**JOINT ARCHITECTURAL BOARD/PLAN COMMISSION AGENDA**  
**MONDAY, AUGUST 21, 2023**  
**6:30 PM**  
**BOARD ROOM, MUNICIPAL BUILDING, 210 COTTONWOOD**

3. Plan Commission will conduct a review of Onyx Hotel, a proposed PUD development ("Project") whose approval and rezoning is being sought by James Kupfer on property tax key HAV0729116 located at 221 Cottonwood Avenue. The Plan Commission will review:

BASIC INFORMATION	
Project Name	Onyx Hotel
Applicant Name	James Kupfer/Adam Hertel
Consulting Planner and/or Engineer	American Architectural Group/Parish Engineering
Existing Zoning	RS-5
Requested Zoning	None yet
Address/Abbreviated Legal	Tax Key HAV 0729116
Comprehensive Land Map Designation	Downtown Mixed Use

SHEET NO:  
**C1.02**

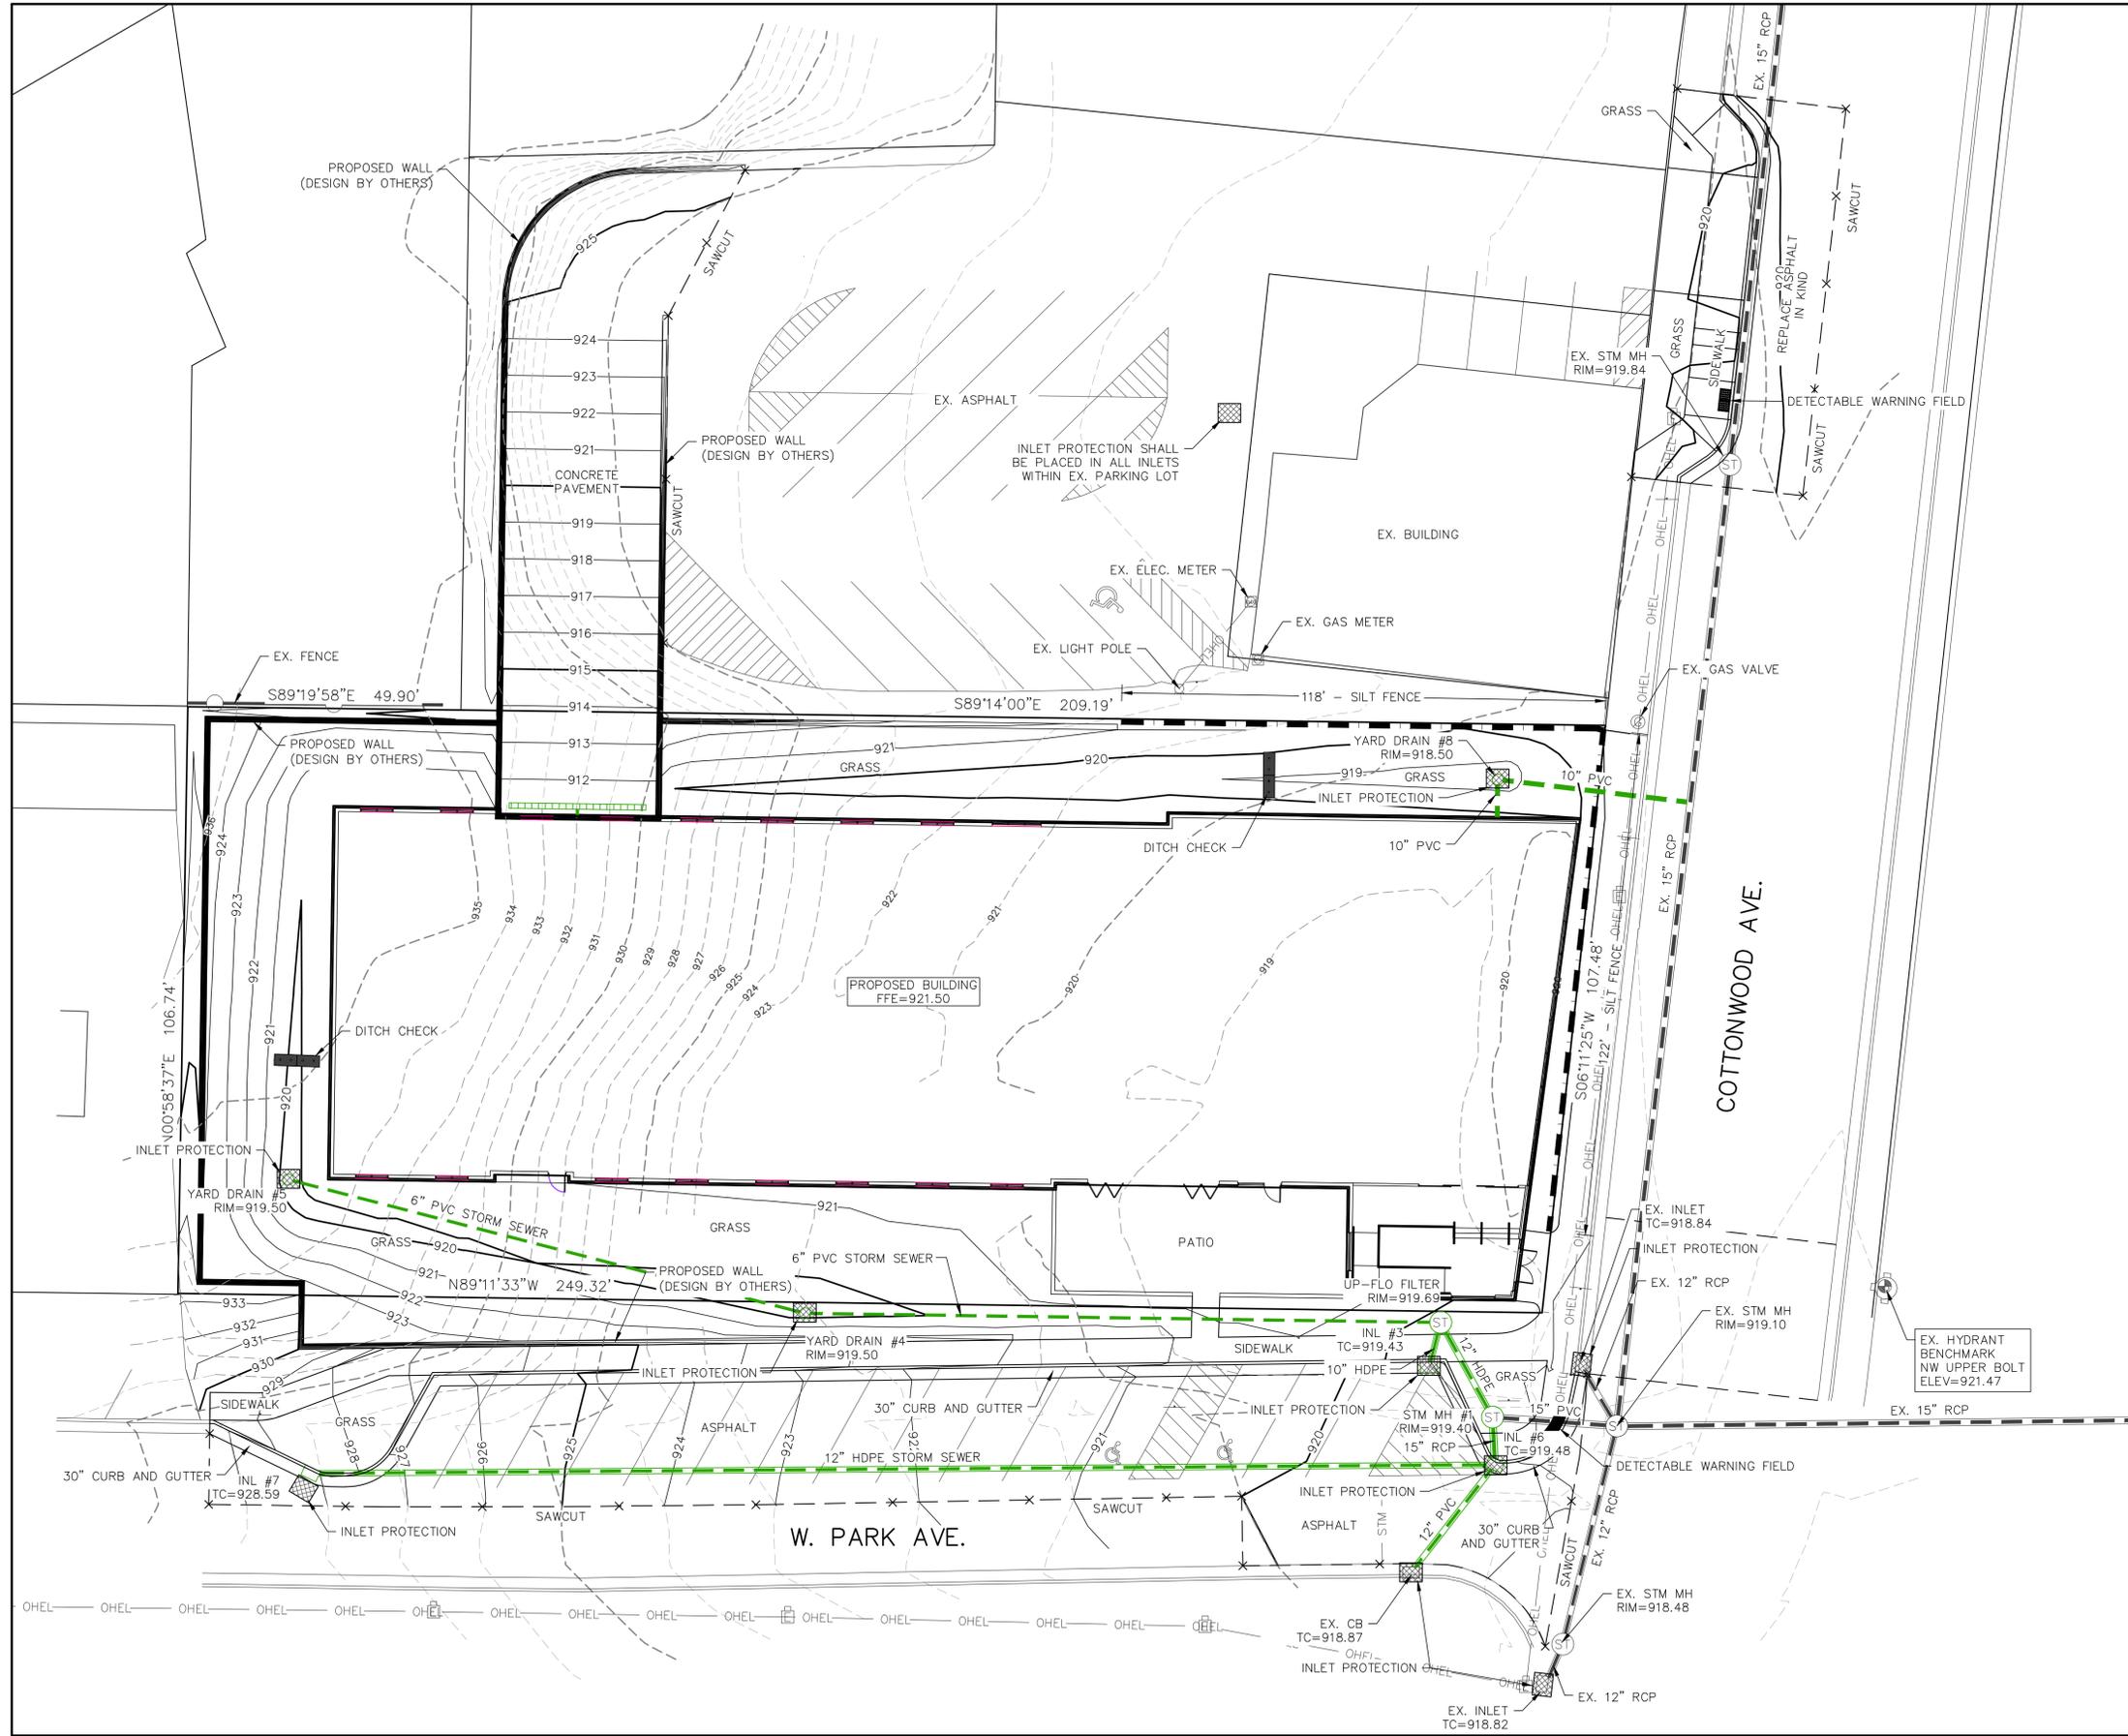
7. Site Plan C1.02
- a. Proposes approximately 600 LF of retaining wall. Geotechnical investigation/borings, structure design, material, height need to be provided.

SHEET NO:  
**C1.04**

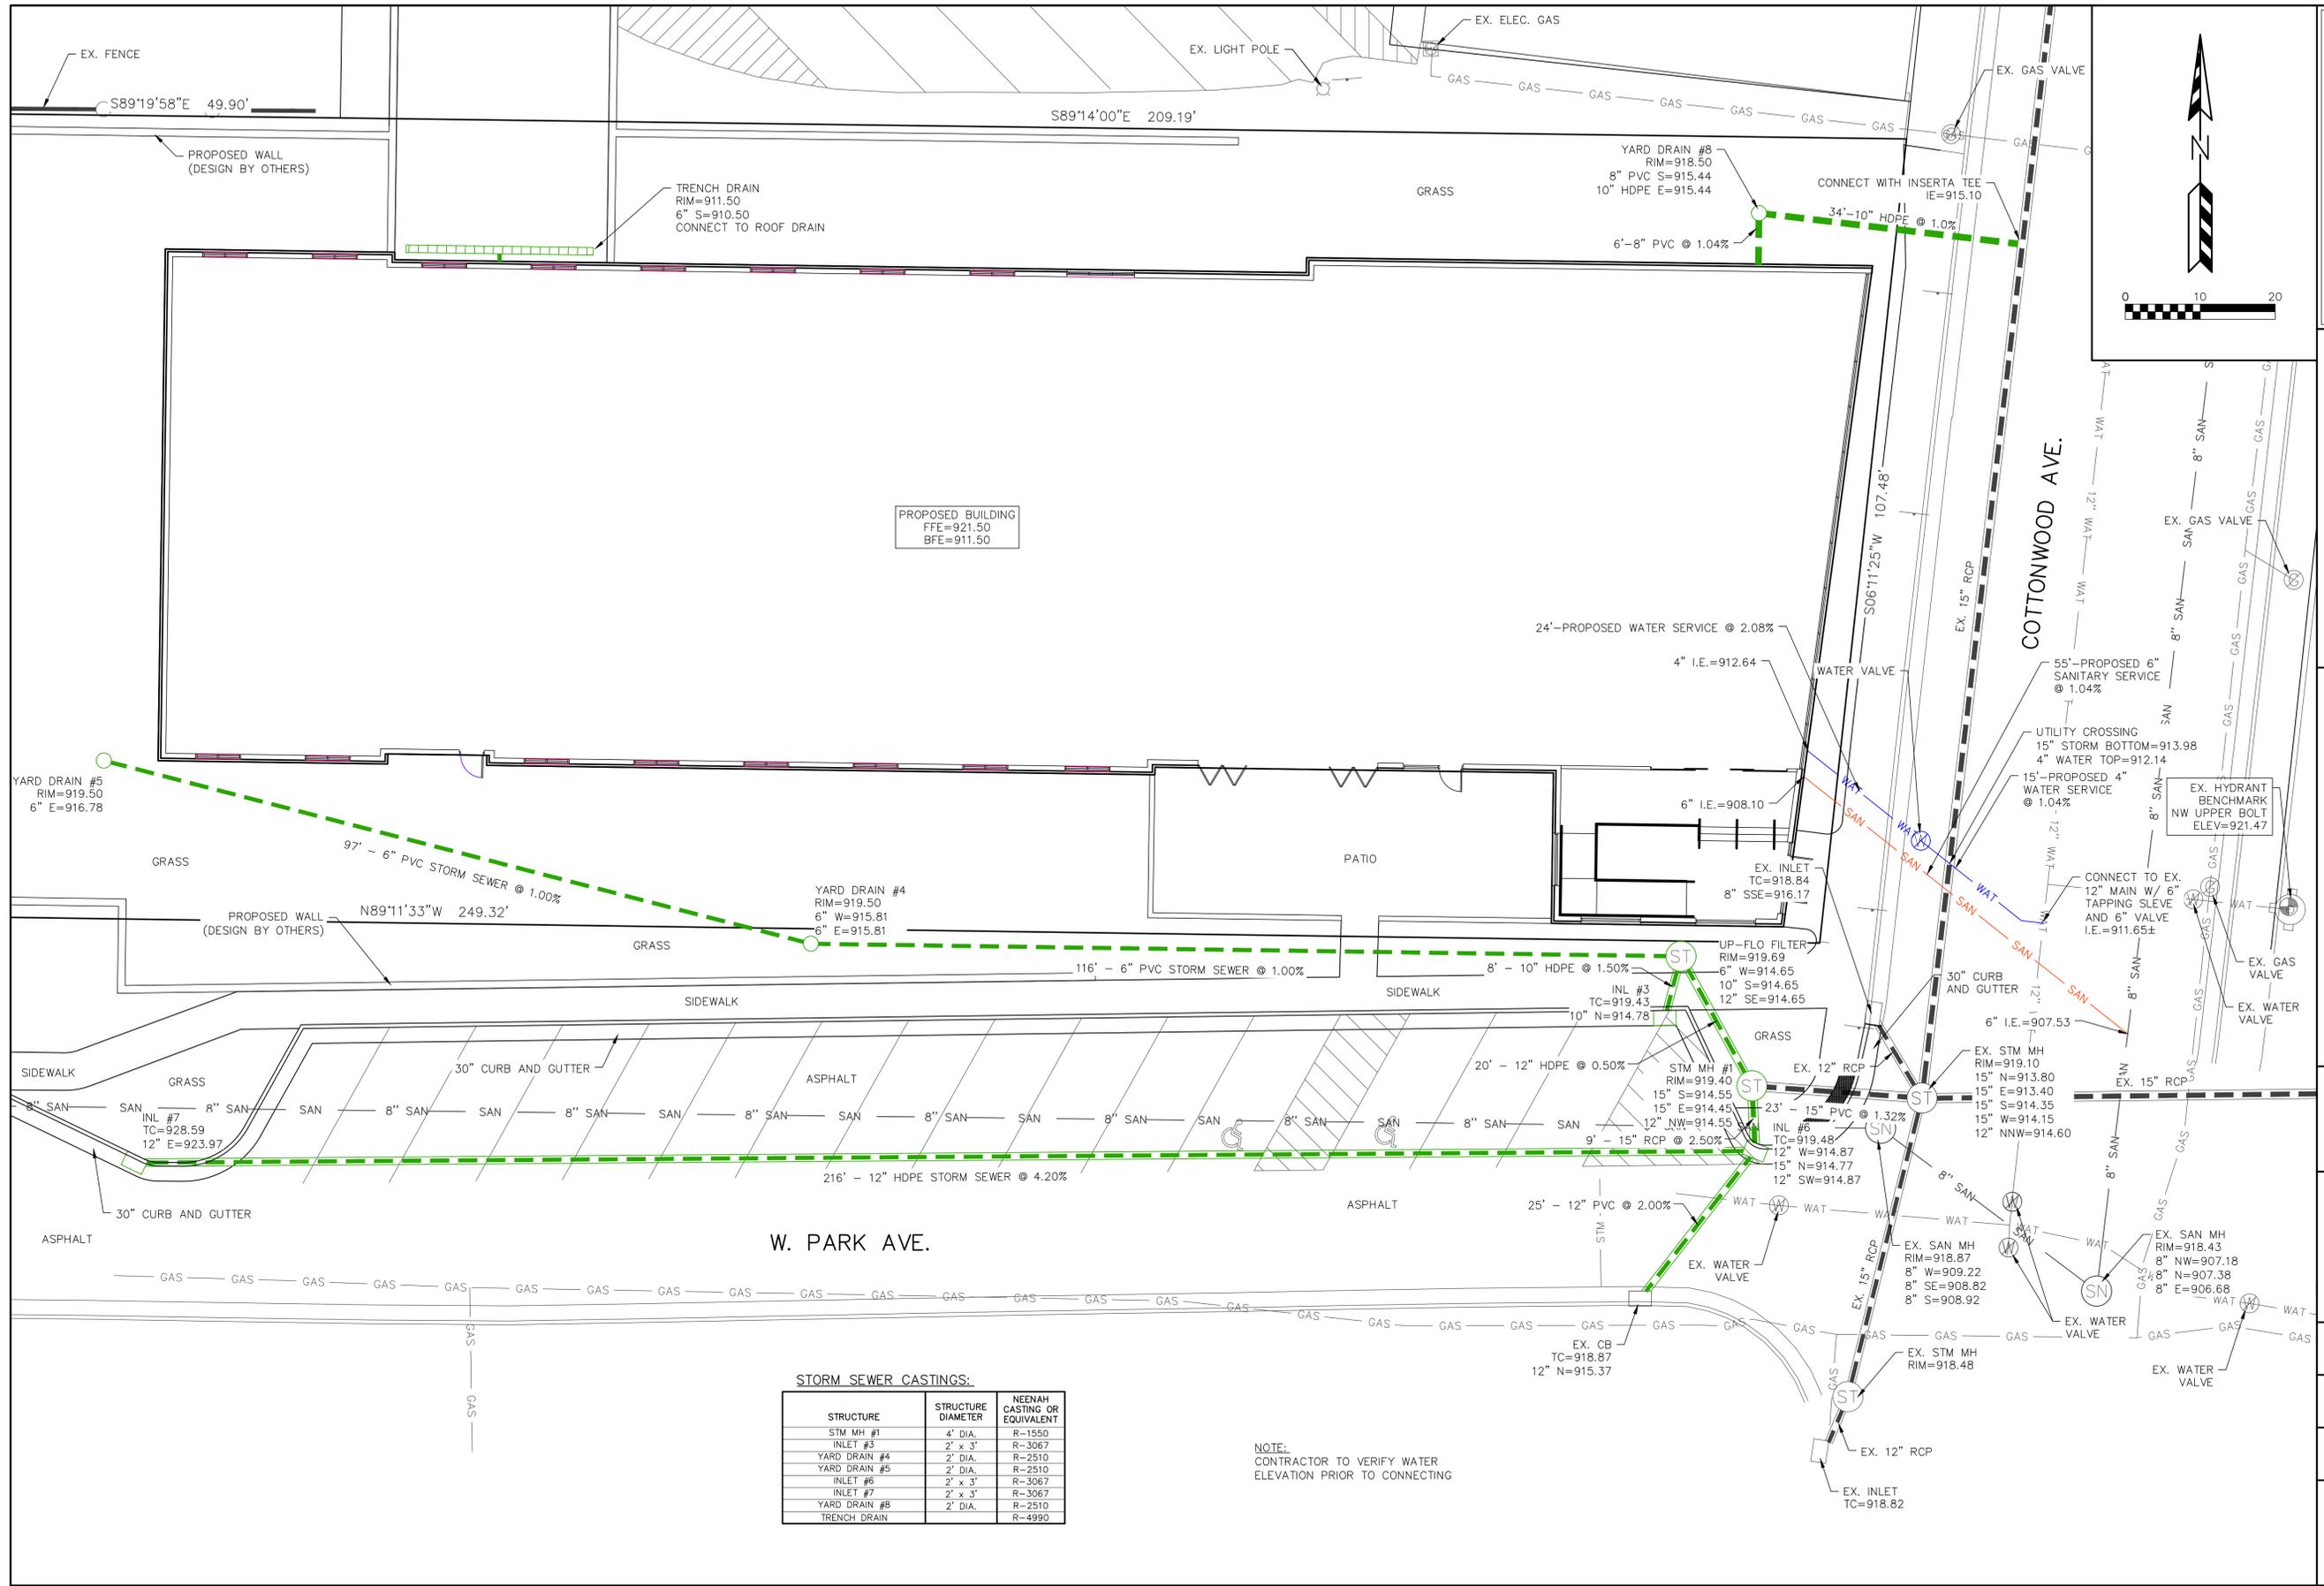
8. Grading Plan C1.04
- a. Show existing contours further around the west perimeter of the site.
  - b. Show existing/proposed grades for municipal parking lot.

- c. Show existing/proposed grades for sidewalk bump out area on Cottonwood. Additional stormwater catch basin may be needed.
9. Utility Plan C1.05
- a. All storm sewer within right-of-way shall be RCP.

SHEET NO:  
**C1.05**

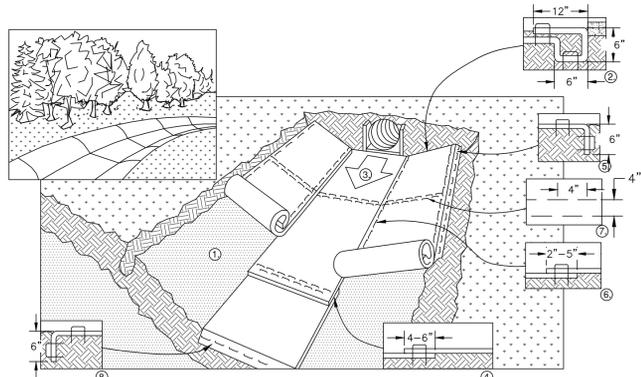
- c. Show drainage plan for grates on ramp into underground parking. Is this gravity or pumped? If pumped, then Village should require a backup power supply and multiple pumps to ensure storm water doesn't enter sanitary system.

- d. Can an additional trench drain be added upgradient on the ramp via gravity storm?
  - e. Where do the roof drains go?
  - f. There is a storm sewer from the inlet in the municipal parking lot to the storm sewer in Cottonwood, show on plans.

- i. Need sizing/details of above and below ground elements of Up-Flo Filter device.
  - j. Need to verify sanitary sewer has capacity – R/M can do this.

SHEET NO:  
**C1.09**

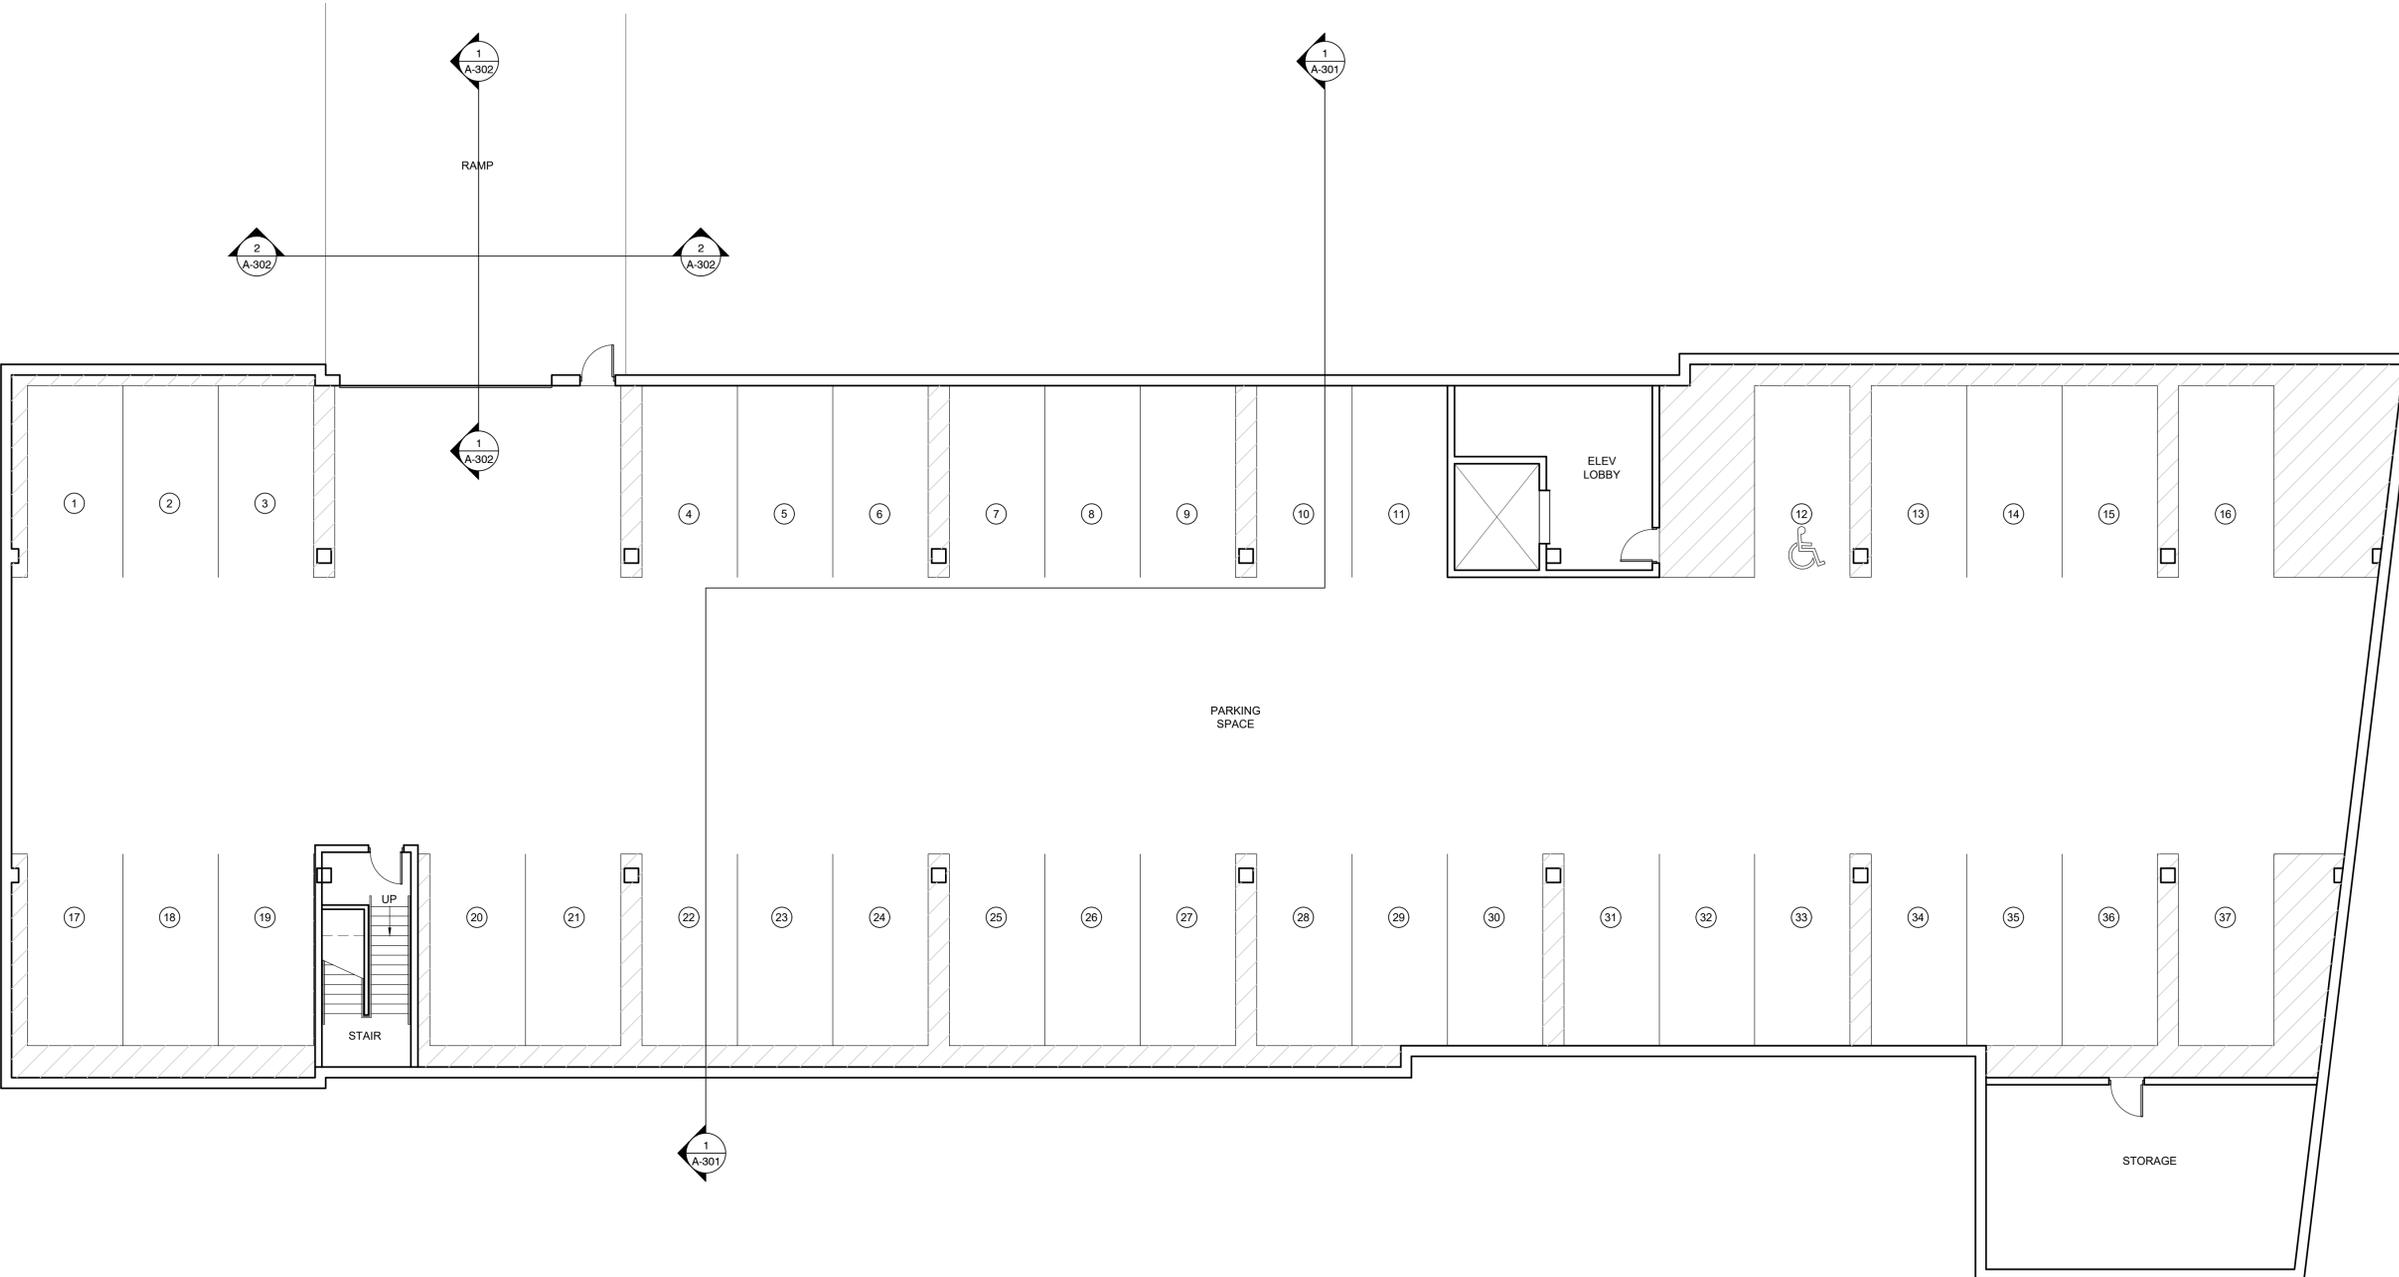
- a. Identify 6" thick concrete sidewalk thru driveways.
12. Utility Details C1.09
- a. Use Village detail for catch basins (w/2' sump) and manhole.
13. Landscape Plan C1.10
